COUNCIL SUBMISSION – Parramatta Light Rail Stage 2 alignment, public consultation

EXECUTIVE SUMMARY

Figure 1 Base case alignment along Grand Avenue (bold line) with foreshore bridge crossing (dashed line)

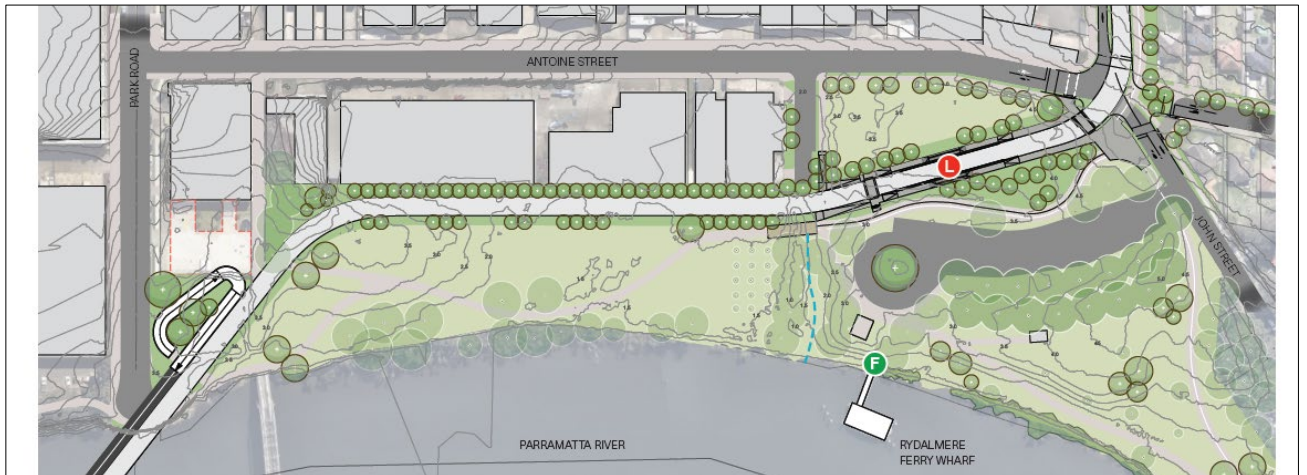
The TfNSW base case alignment for Camellia to Rydalmere follows Grand Avenue to the east and across the River to connect with John Street and South Street (Figure 1). The alignment travels perpendicular through a foreshore park and commuter parking. This alignment is not favoured by TfNSW due to utility and other costs associated with Grand Avenue. It is acknowledged that any light rail line will impact the foreshore park.

However the key cost for Council and the local community is the loss of a large tract of parkland and the narrowing of the park to form a transit corridor. Figure 2 does indicate the final design, the impact of earthworks and the necessary embankment. This alignment is also likely to disturb historic contamination within the park.

The TfNSW A9 alignment could be supported if it ran immediately south of Antoine Street and not through the foreshore park. Foreshore open space is a precious community asset and TfNSW should take a long term view of the light rail asset and alignment.

Council supports the TfNSW A9 alignment, but only if it runs south of Antoine Street and not through the foreshore park. An A9 alignment that runs within the foreshore park must result in compensatory land to Council and/or open space embellishment.

Figure 4 Base case alignment showing single Stop in Camellia, at the connection with PLR Stage 1

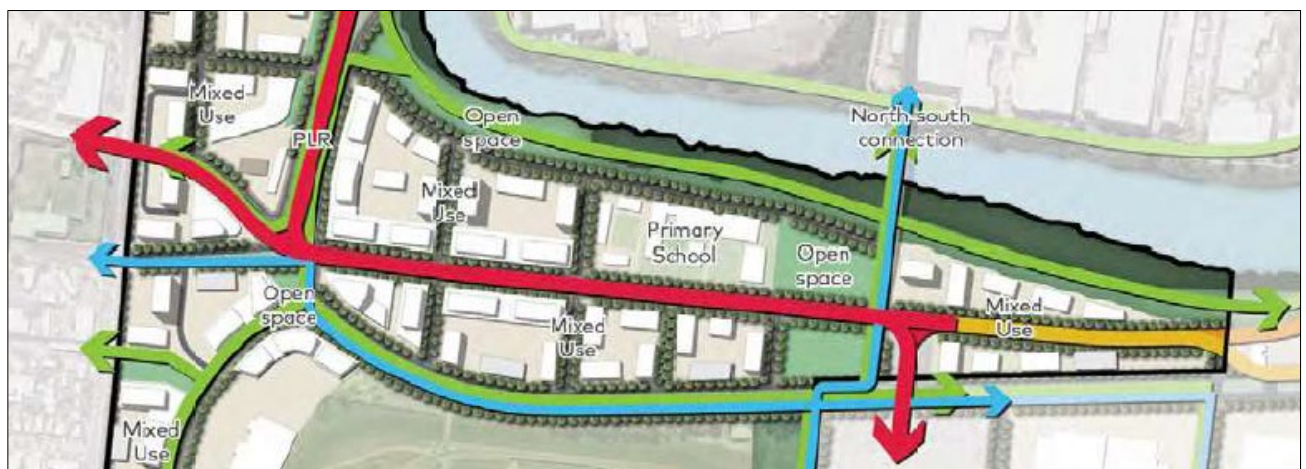
The base case alignment (Figure 4) shows a single stop at the western end of Camellia, at the connection with PLR Stage 1. The Draft Camellia-Rosehill Place Strategy (Figure 5) indicates the location of a Primary School within the town centre, in the centre of the development area. The light rail stop at Camellia should be centred within the potential development site and more convenient to the future school.

The alignment at Camellia should be consistent with the Draft Camellia-Rosehill Place Strategy – with the

light rail stop centred within the potential development site and more convenient to the future school in that Strategy.

Figure 6 Light rail alignment across Ken Newman Park (red) and connections needed (yellow)

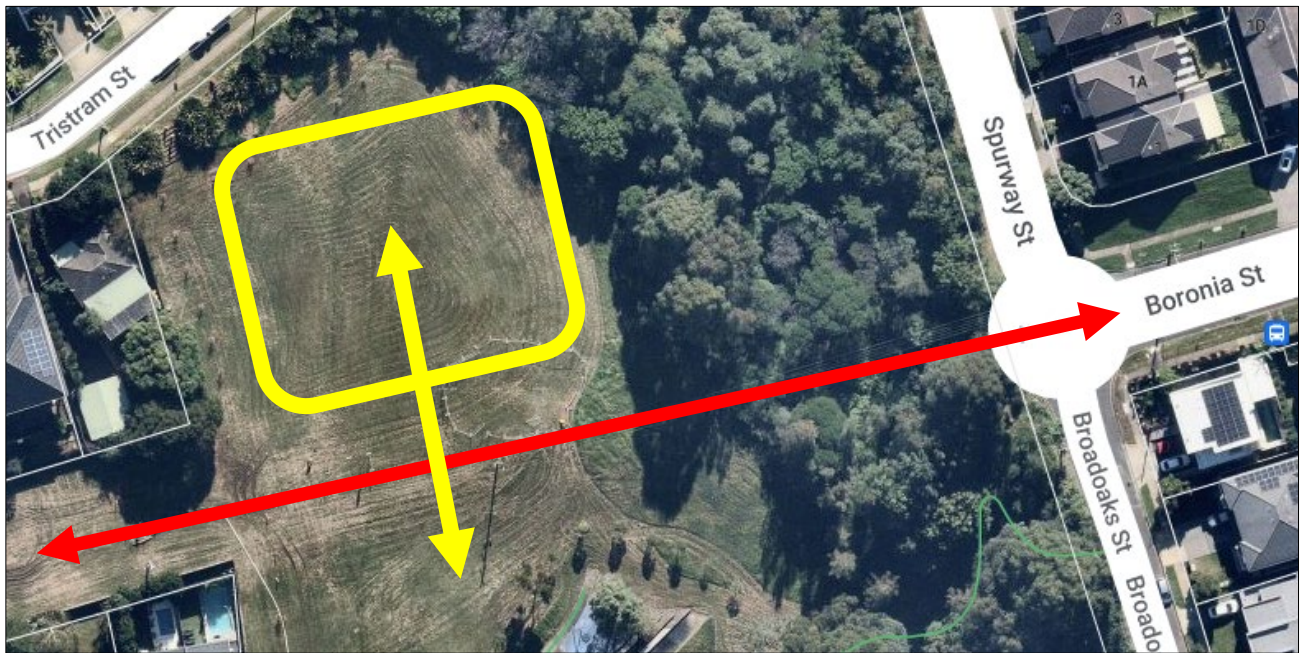
Figure 6 indicates the light rail alignment running through Ken Newman Park and connecting with Boronia Street. The track infrastructure will form a barrier and split the park. TfNSW has advised that a design solution is required to link the north and south portions of the park, and that embellishment work on the northern portion of the park can be carried out as part of the Project to make the northern portion more useable for the community. This is in keeping with the design led theme of Stage 2 of the light rail.

In order to partly offset the impact of the Project on Ken Newman Park, Council request TfNSW to develop and fund, in consultation with Council, a specific design plan and works to Ken Newman Park, with the aim of minimising the light rail isolating the upper and lower portions of the park, and embellishing the upper portion to make it more useable for the community.

Figure 7 Proposed green track areas

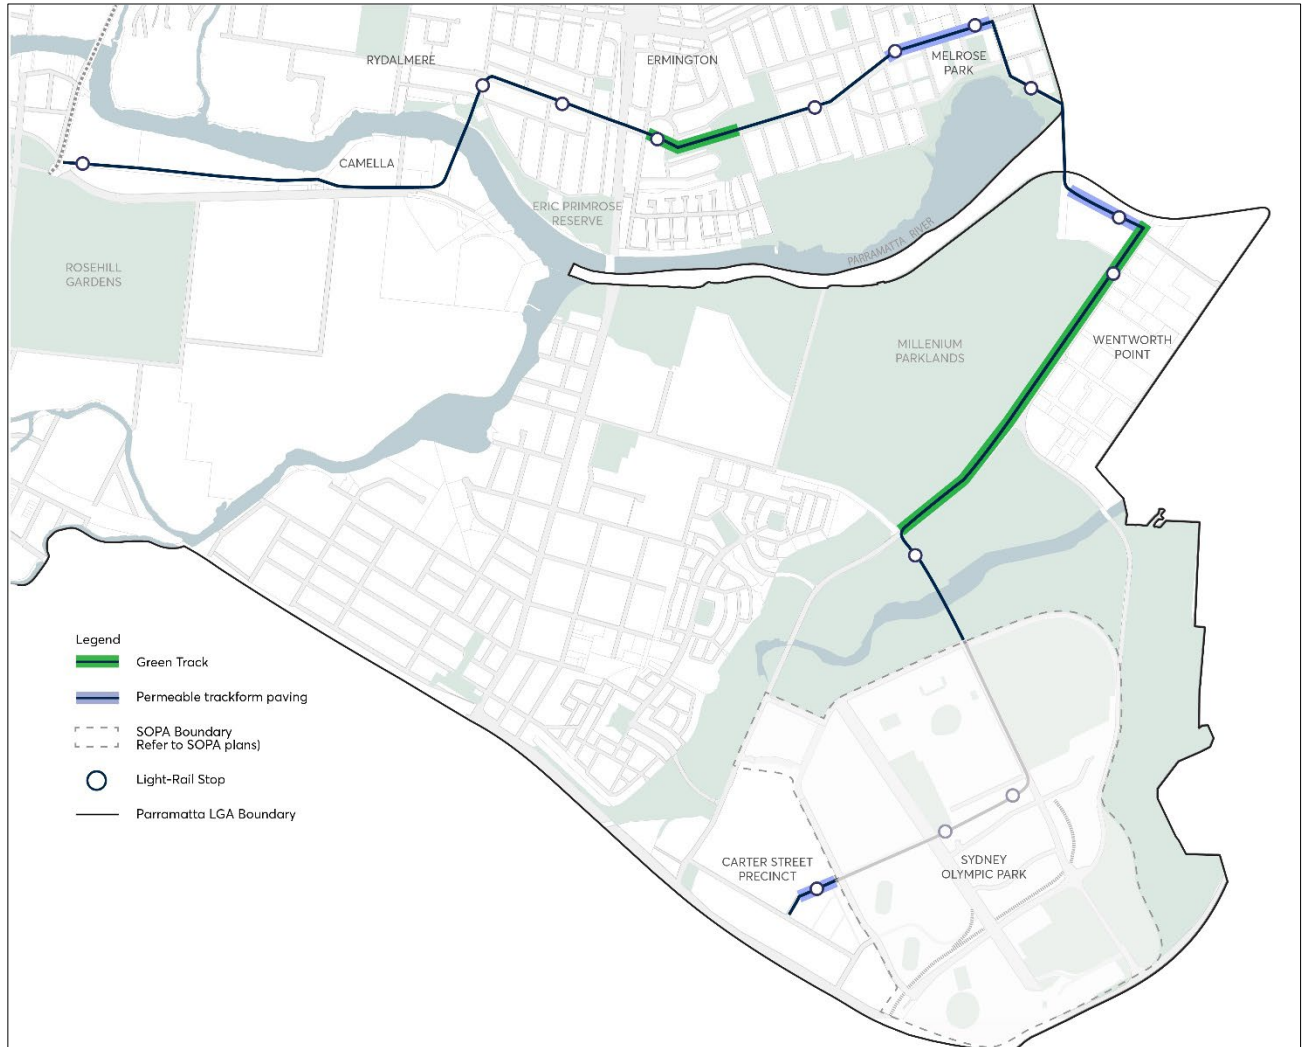
The TfNSW PLR Stage 1 leadership are justifiably proud of the 1.3km of green track along the alignment. However for Stage 2 there are no designated green track areas. Green tracks should be provided where the alignment runs through existing green space or where there are substantial hard surface areas.

Figure 7 indicates where green track areas could be provided along the alignment, namely the green space between South Street and Boronia Street and the long Hill End Road hardstand strip. Figure 7 also indicates where permeable track form paving could be provided, for a softer public domain finish.

Council requests TfNSW to provide green track and permeable paving per Figure 7.

Figure 8 Proposed wire free running areas

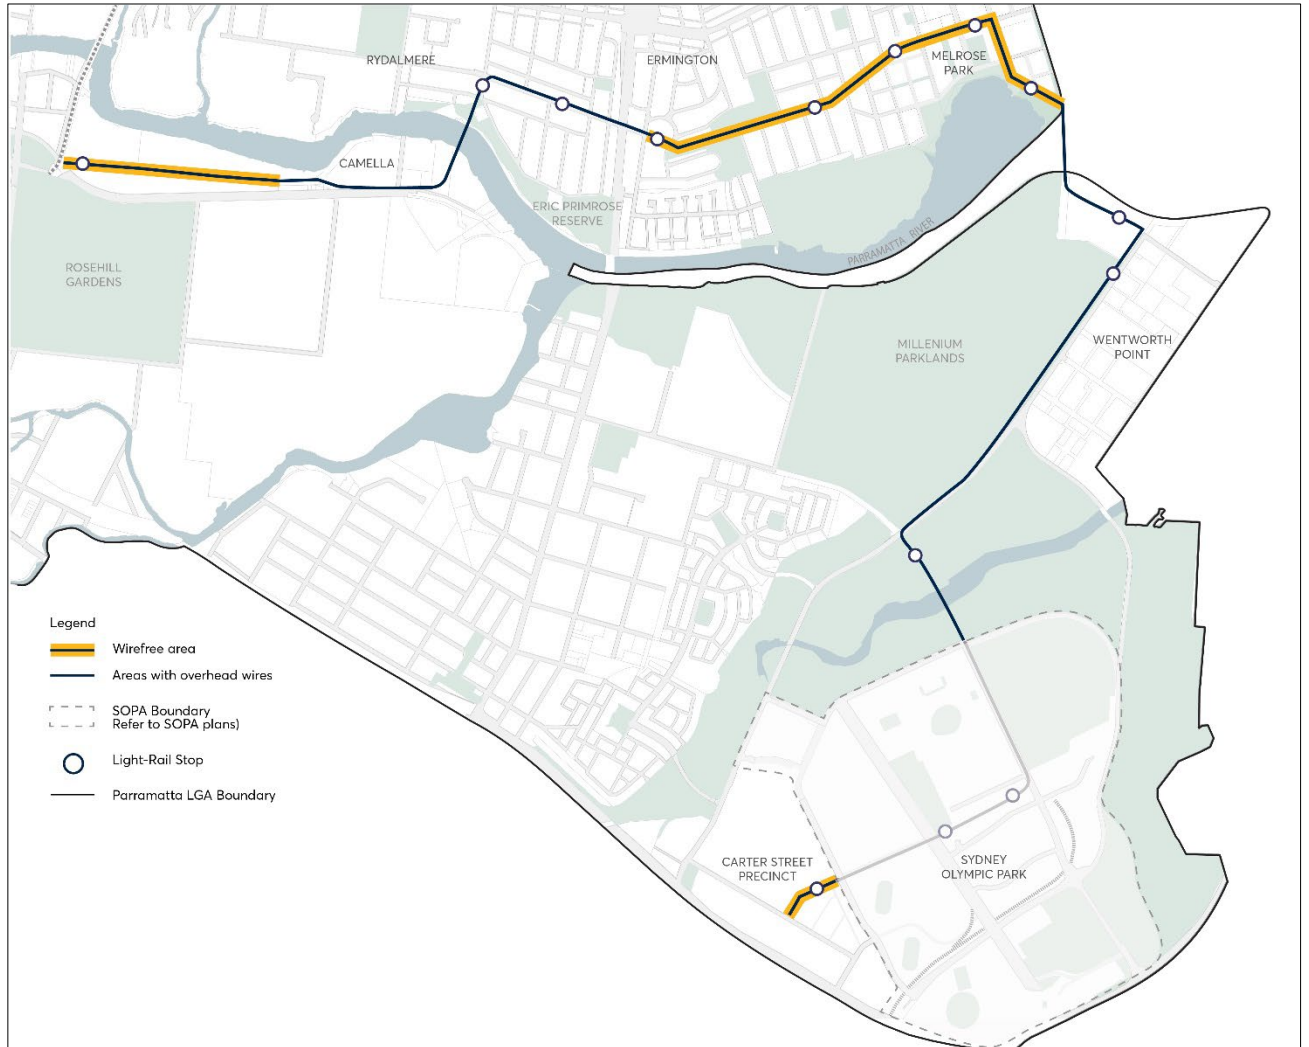
Wire free (catenary free) areas can considerably improve the visual impact of the Project by limiting most infrastructure to track level only. Figure 8 indicates that wire free running should be provided in the future Camellia town centre, the residential green space east of South Street, through Melrose Park, and through to the River, along with the Carter Street precinct in Sydney Olympic Park.

Council request TfNSW to provide wire-free areas per Figure 8.

Figure 13 Narrow, linear utility corridor and green space between South Street & Boronia Street

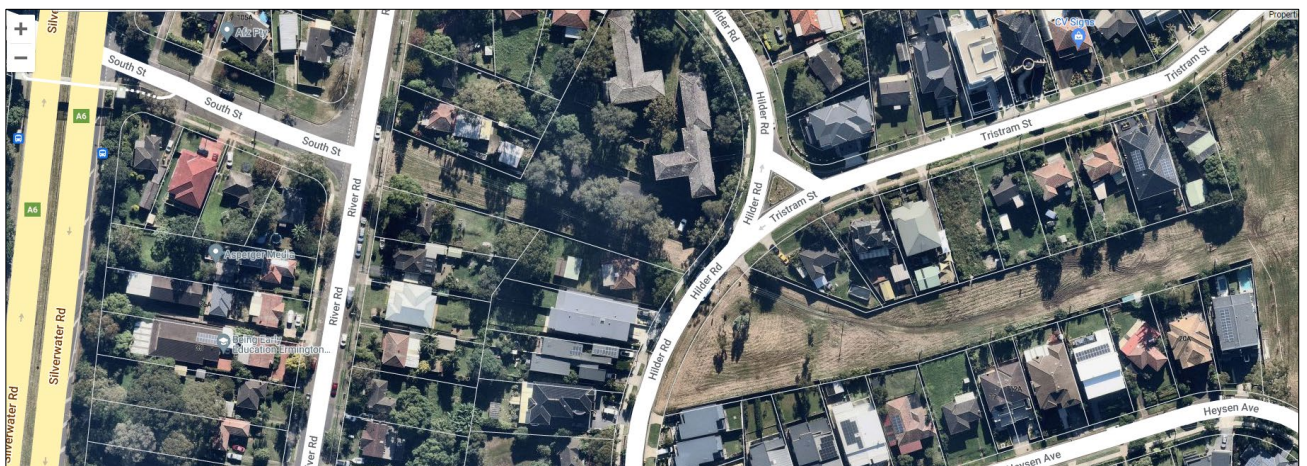
PLR Stage 2 runs through approximately 2km of low density residential streets, including some 400m of linear green space behind houses and through Ken Newman Park (see Figures 9 and 13) and approximately 2km of existing high density residential - not including any future high density residential at Camellia. The built environment context is quite different to Stage 1, which is primarily commercial development and an existing heavy rail corridor.

Creating a new light rail line through existing residential roads and green space will require design led solutions and the best possible noise and vibration mitigation and visual amenity measures. This includes:

It is recommended that the protection of residential amenity during light rail operation be a strong focus of the EIS, employing world class practices to minimise ground-borne vibration, ground-borne noise and airborne noise from rail operation.
